Environmental Statement
Appendix H2
Outline Design Briefing Note for
Natural England. March 2022
Langstone FCERM SCHEME

Langstone FCERM Scheme - Review and refinement of outline design options

Figure 8: Outline Design options for Frontage 5 (High Street to Royal Oak) - king post wall (top) or parapet wall (bottom)

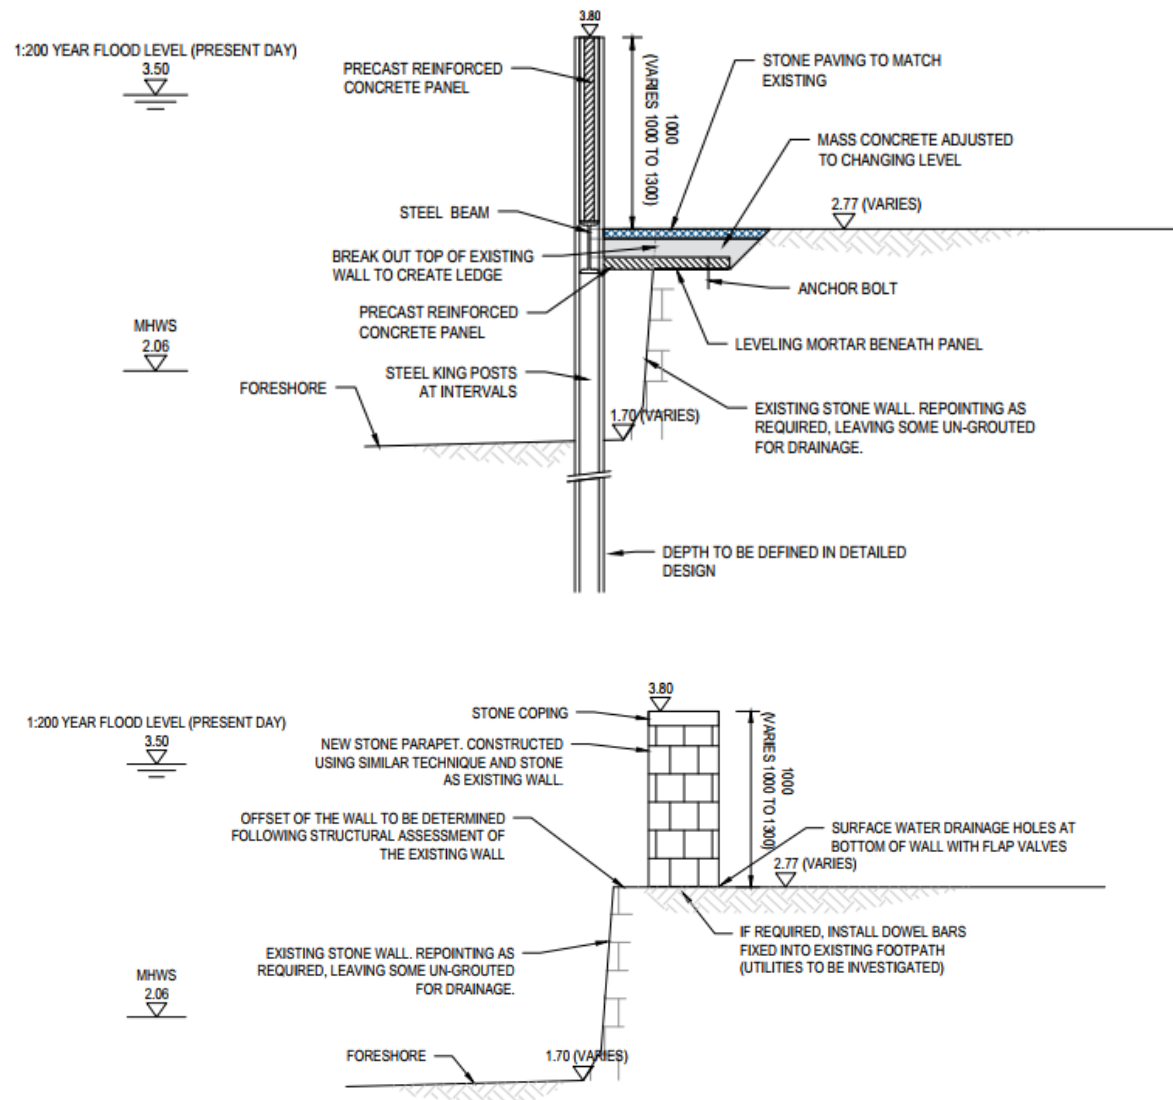
The outline design for Frontage 5 was to install a flood gate across Langstone High Street and construct either a parapet wall on the alignment of the existing wall or to construct a king post wall with precast reinforced concrete panels and cladding in front of the Royal Oak, as shown in **Figure 8**. Following the results of the Structural Investigation, seepage analysis and receipt of Early Contractor Involvement (ECI) advice, both of these options have since been ruled out because they do not provide a continuous impermeable barrier, and therefore seepage would be expected to occur, and hence they do not meet the design requirements of the scheme to prevent future erosion risk as well as flood risk. Furthermore, the Structural Investigation found that the existing quay wall is in poor condition with multiple voids and a residual life of less than 10 years. Therefore, the existing quay wall is unsuitable for reuse and incorporation into the scheme and a new structure is necessary to provide the required design life and standard of protection to meet the scheme objectives.

In addition to the outline design, an alternative design solution was considered to utilise the existing Royal Oak building as part of the flood defence, however this solution was also ruled out, for similar reasons as described above. Cyclic seawater exposure on the structure will increase the risk of excessive moisture and increase the risk of rotting to timber elements, and ultimately lead to structural issues. Therefore, minimal intervention to the existing timber frame structure is recommended and use of the existing structures was ruled out. Seepage analysis indicates that a cut-off curtain is required in this location with a nominal 1m embedment into less a permeable stratum (i.e., Alluvium/Chalk Dm). A pile toe level of -0.4mOD minimum is required to prevent seepage through to the landward side of the defence. These results combined, therefore mean that it is not possible to make use of the existing building as the flood defence without any modifications as the design requirements of the scheme would not be met.

The updated design is to construct a glass topped clad sheet pile wall with base apron buried beneath the foreshore. The reinforced concrete apron will enable the sheet pile toe to be moved further from the existing wall foundations, reducing the chance of hitting obstructions during piling and also vibration damage. It will also enable a thinner wall to be constructed above the foreshore, minimising the amount of permanent encroachment into the intertidal foreshore. This updated design option will also provide a long-term benefit to and protection of the Grade II listed buildings along this frontage with respect to climate change and sea level rise. For the High Street, the design remains the same as at outline design, i.e. installation of a flood gate across Langstone High Street.
